Report to Planning and Environment Committee

Subject: 135 Villagewalk Boulevard
Public Participation Meeting
SPA23-005 – Ward 7

Date: May 23, 2023

Figure 1: View from internal to the site.

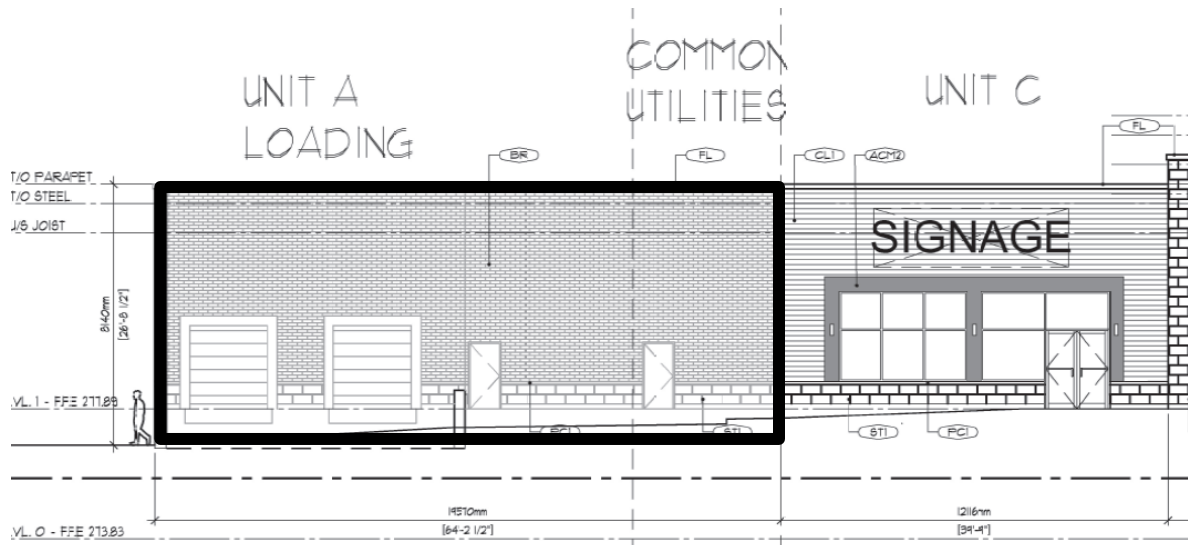
Comments received through the circulation process noted concerns with the location of

appearance of the loading bay. The garbage and loading bay are screened by a low-masonry wall along Villagewalk Boulevard and internal to the site, facing east. The loading bay area is only visual from internal to the site. The elevations do not incorporate the landscape screening that will also be provided. Staff have no concerns with the proposed loading bay area, including vehicles accessing the loading bay. Figure 1 and Figure 2 below identifies the proposed loading and garbage location along with the low masonry wall for screening.

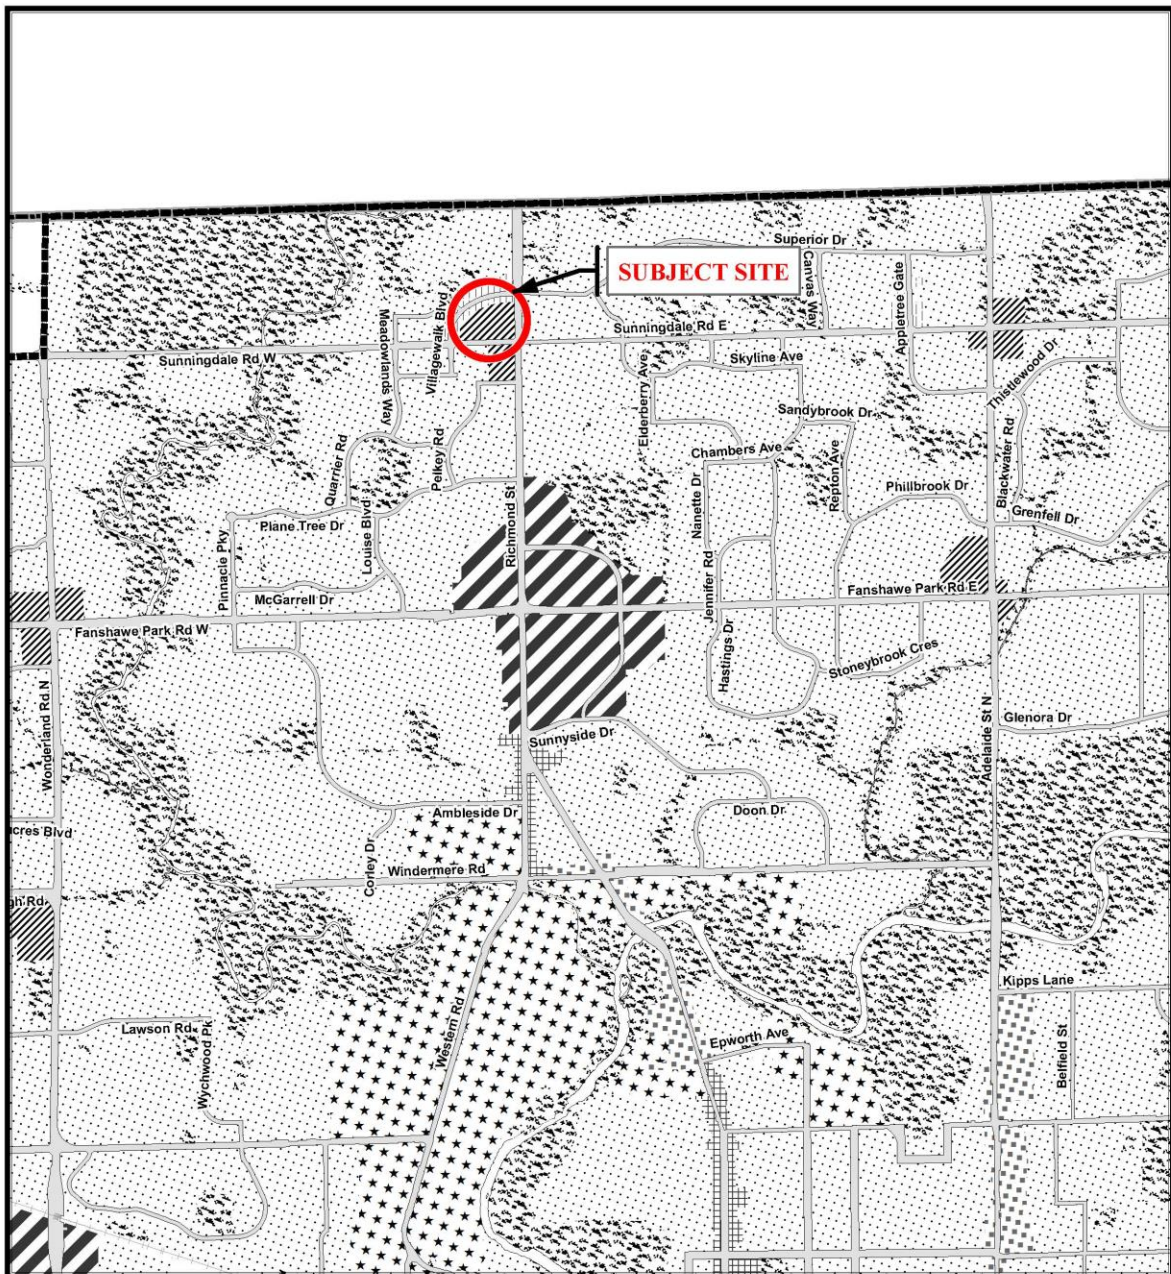
The Panel notes that the canopies along the North and East elevations may be superfluous. Consider deleting these canopies to give the canopies along the South elevation and North-East corner of Building M more prominence.

The Panel appreciates the landscaping and pedestrian pathways located at the North-East corner of Building M. Consider enhancing the corner further with paved amenity space and larger pathways to establish it as a public amenity space and pedestrian access point. Increased glazing, a unique cladding material, and/or a taller parapet could further emphasize this corner as a pedestrian access point.

The canopies depth vary between 5'-8' depending on their location and span within windows and structure. Further structural input will be required to expand the coverage of the canopies.

The submission package successfully acknowledged the extreme grading slope in the North-South direction. The 8' wide ramp and sidewalk wrapping around the building has enhanced landscaping around it. At the bottom of the 8' wide pathway, in the North-East corner, there is a raised hardscaped plaza feature that provides the opportunity for outdoor seating, bike racks and a low landscaped wall.
